To: For file CR2022-0005
From: Michelle Barron
Date: July 19, 2024
Re: CR2022-0005 Verhoeks - BOCC requested information update

PUBLIC HEARING – REQUEST BY TANNER VERHOEKS OF HAVEN IDAHO FOR A CONDITIONAL REZONE FROM AN “A” (AGRICULTURAL) ZONE TO A “CR-R-1” (CONDITIONAL REZONE - R-1 RESIDENTIAL) ZONE, CASE NO. CR2022-0005

1. SEPTIC - "Engineering details on the viability of septic systems with the concern of basalt ... and other rock that is just under the surface."
2. EMERGENCY SERVICES - "Solicit information from fire, police, and ambulance on the viability of the response times to this location."
3. SCHOOL - "The viability of the applicant's impact on the school district."
4. DENSITY - "Secondary houses to be completely off the table."
5. DA - "Further discussion about the development agreement."

PRELIMINARY PLAT FOR:
HAVEN CREEK SUBDIVISION
SITE PLAN AND UTILITIES

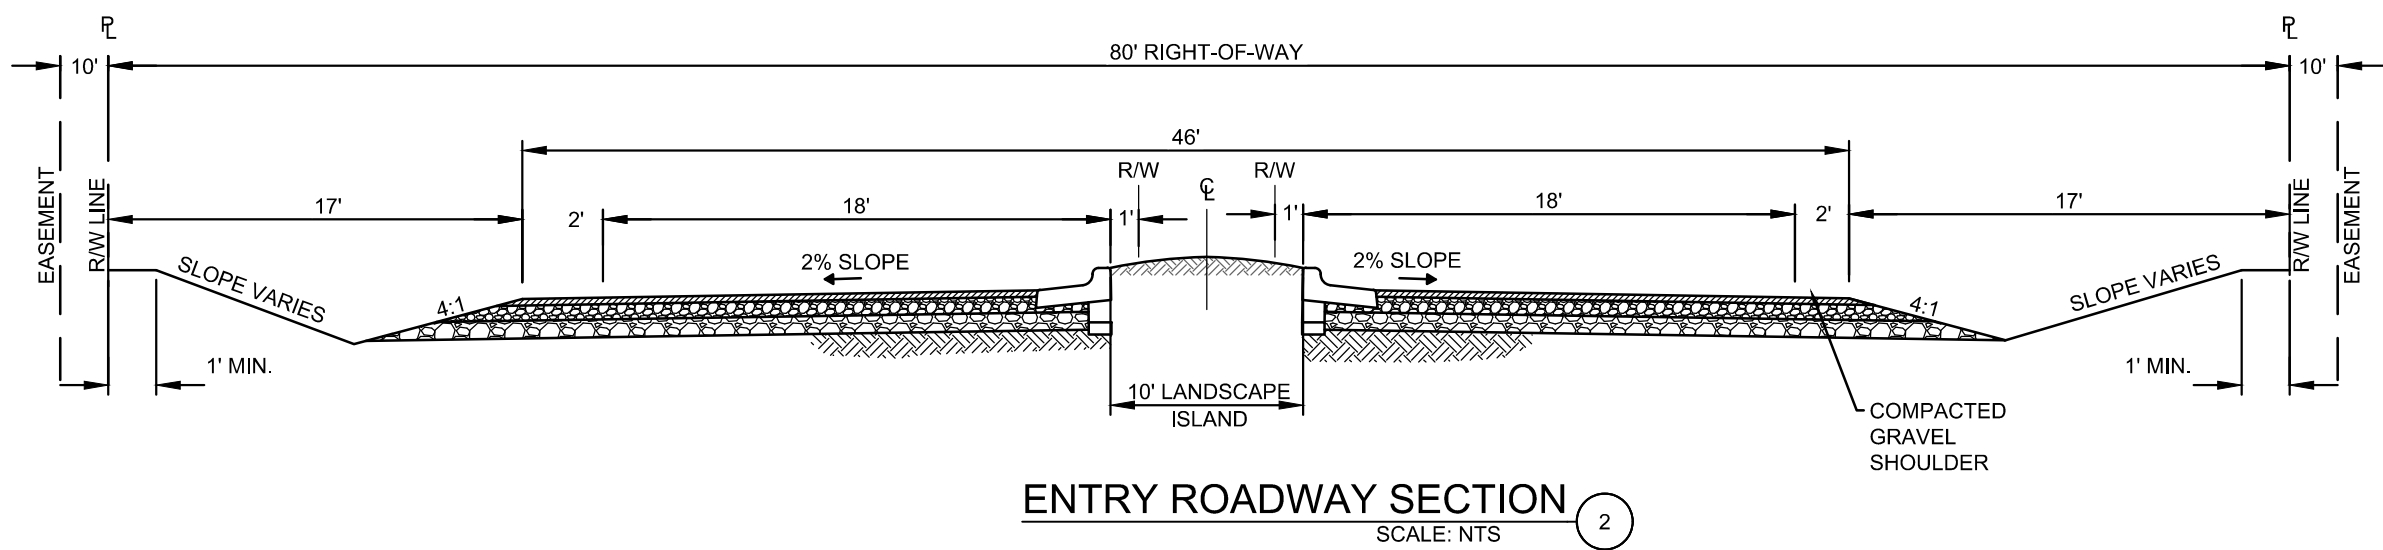
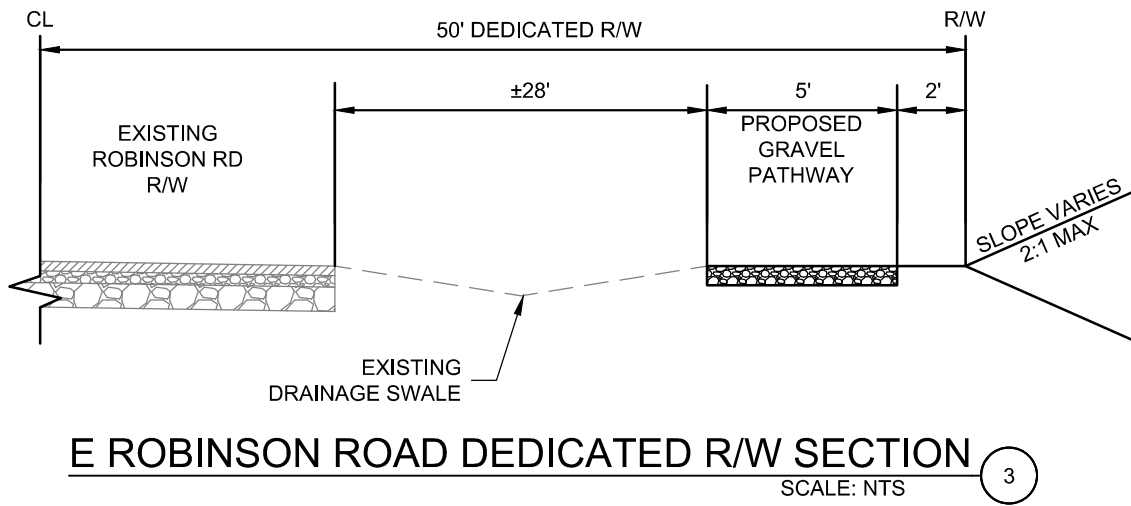
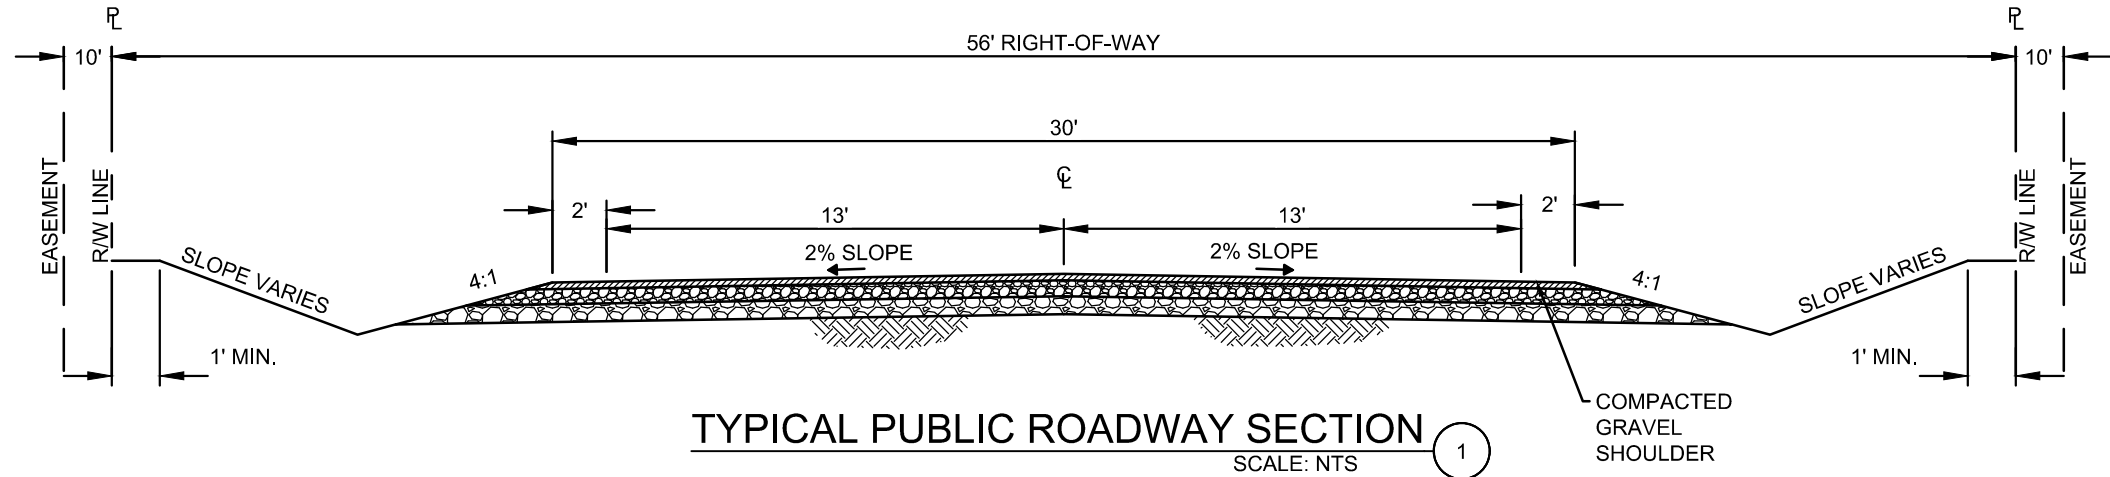
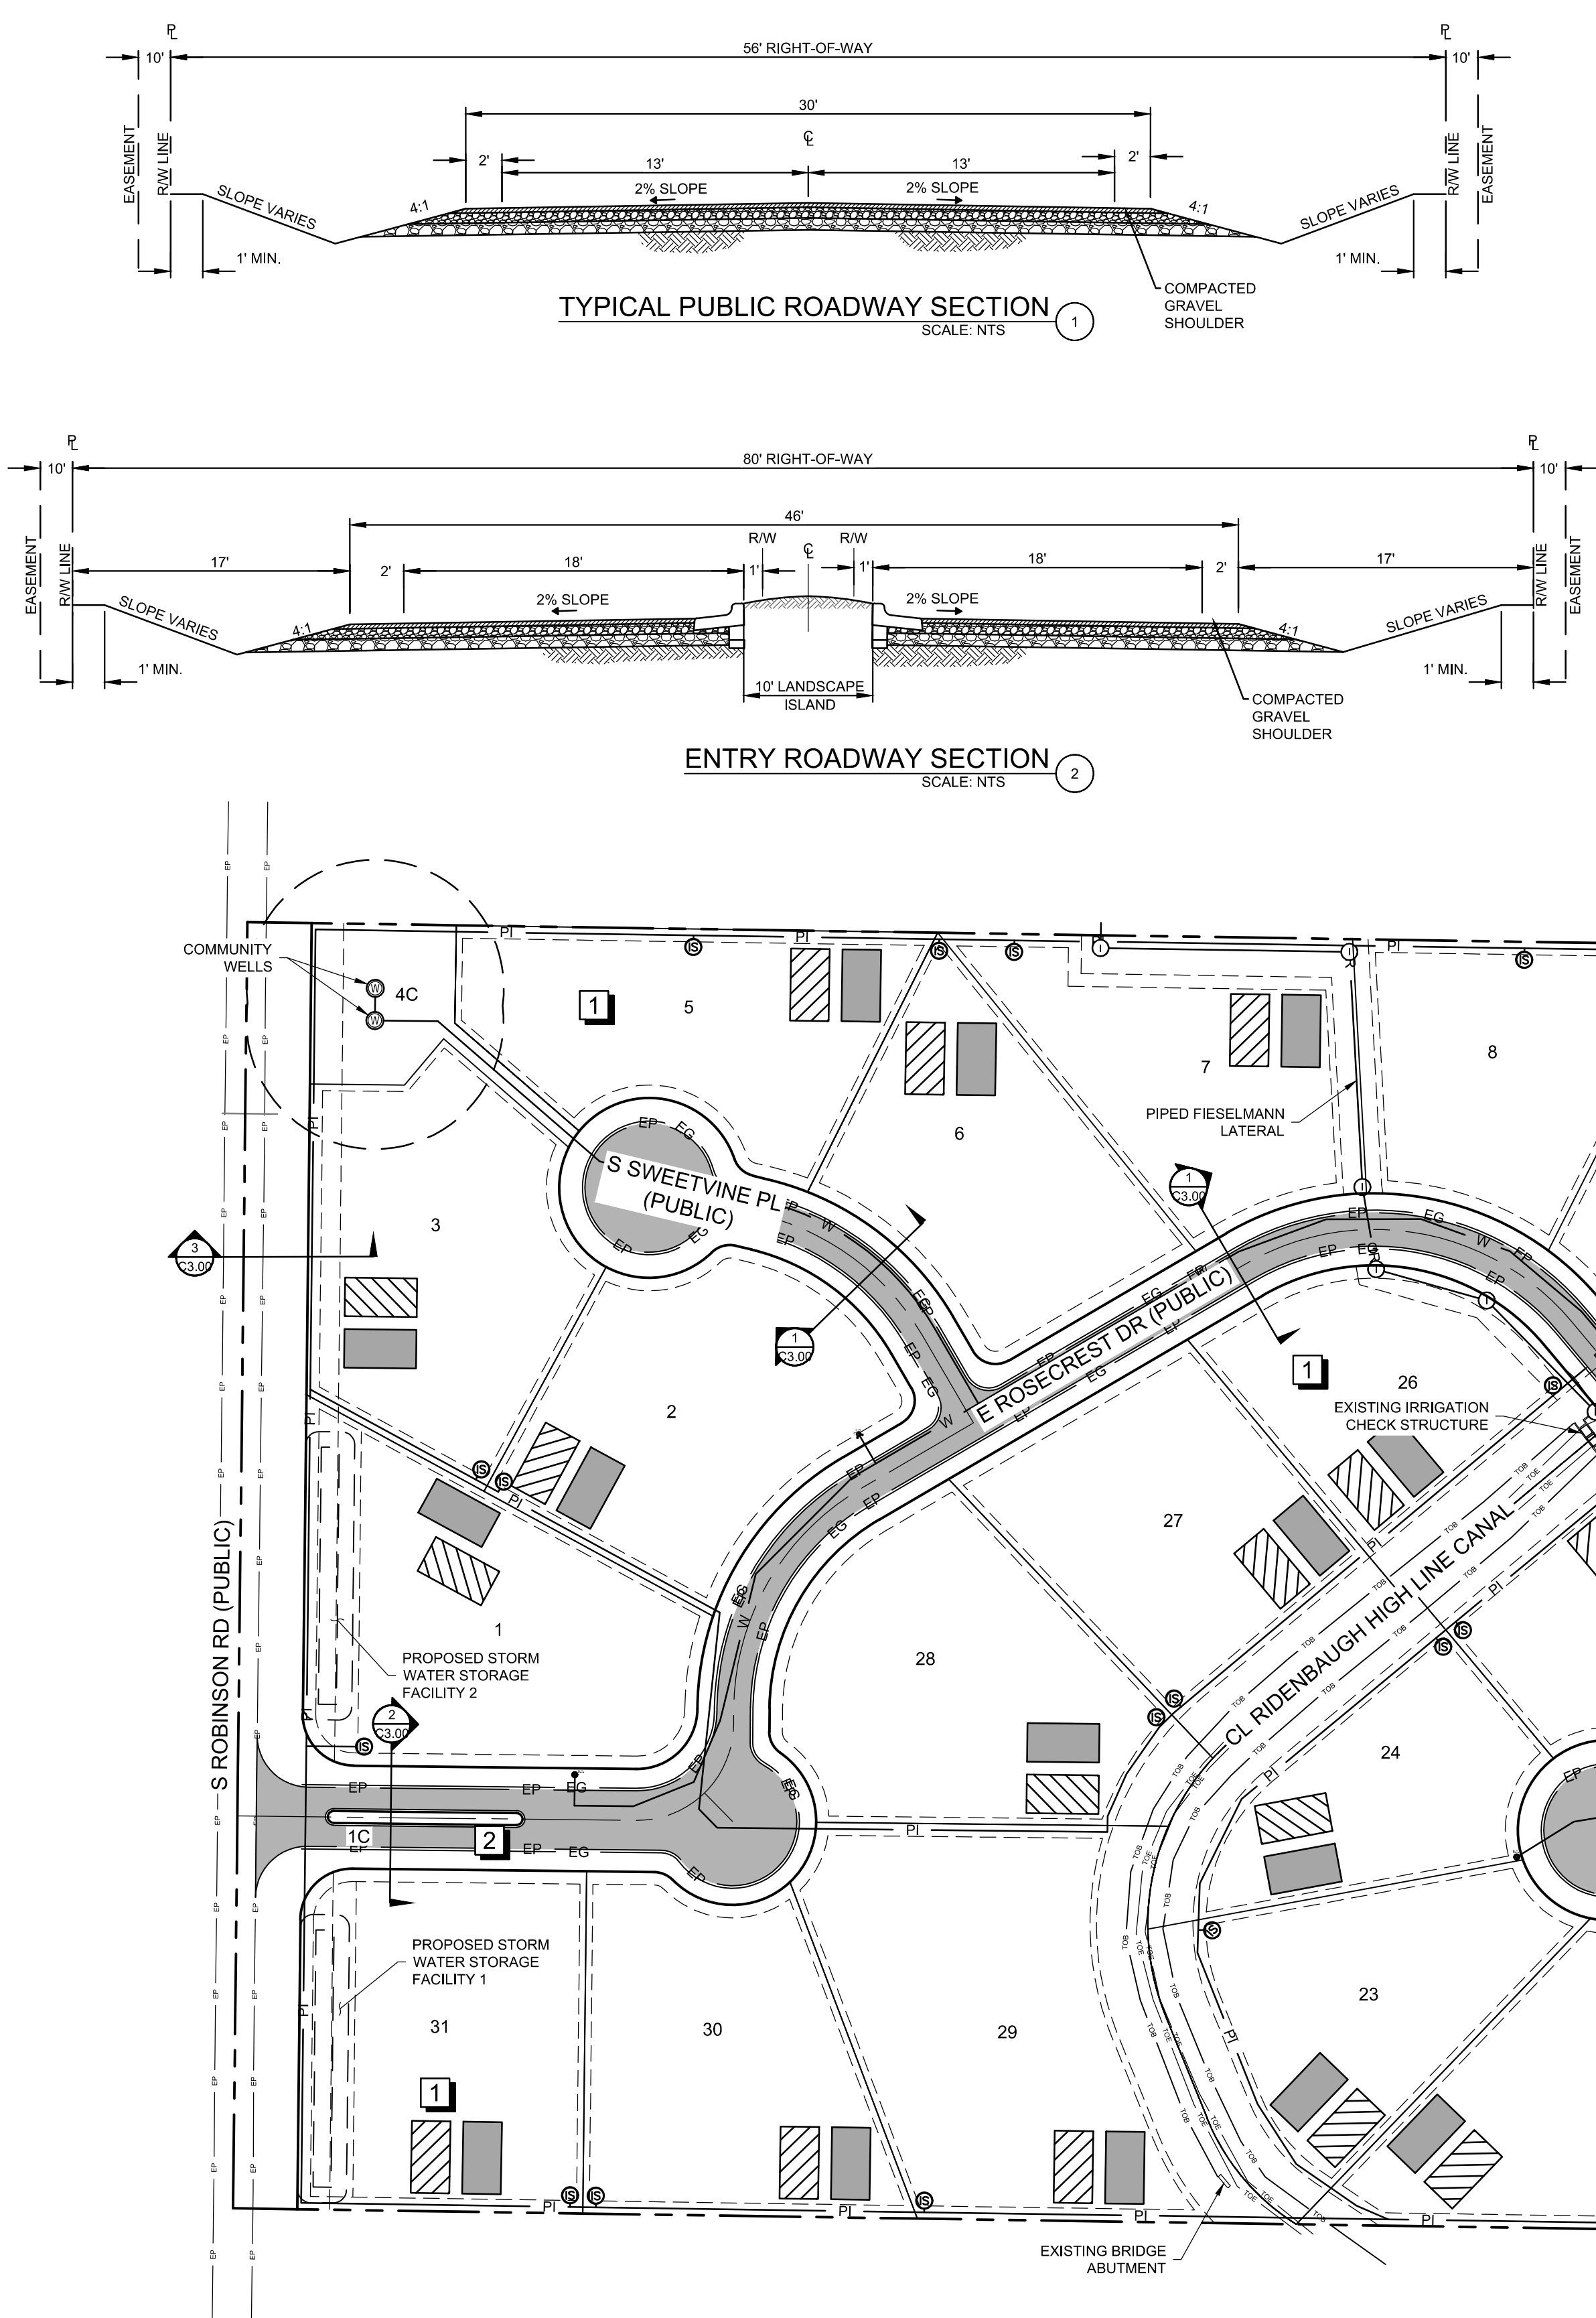
Plans indicate a single fire service roadway connection from south Robinson Road. This service roadway shall be maintained unobstructed with approved cul-de-sacs available for fire apparatus turn around. A secondary access, complying with IFC section D107.2, may be required if more than 30 buildable lots are proposed. No Parking Fire Lane signs shall be installed in areas determined to have significant potential to obstruct emergency access and firefighting operations. Refer to IFC appendix "D" sections D103, D103.6.1, & D103.6.2 for details.

A fire hydrant water distribution system and approved fire hydrants are required. At least one fire hydrant shall be available along residential service roadways and within 600 lineal feet of the furthest exterior portion of each future residential building. Hydrants and fire flow shall be designed to meet the minimum requirements of IFC appendix B105.1 for one- and two-family dwellings.
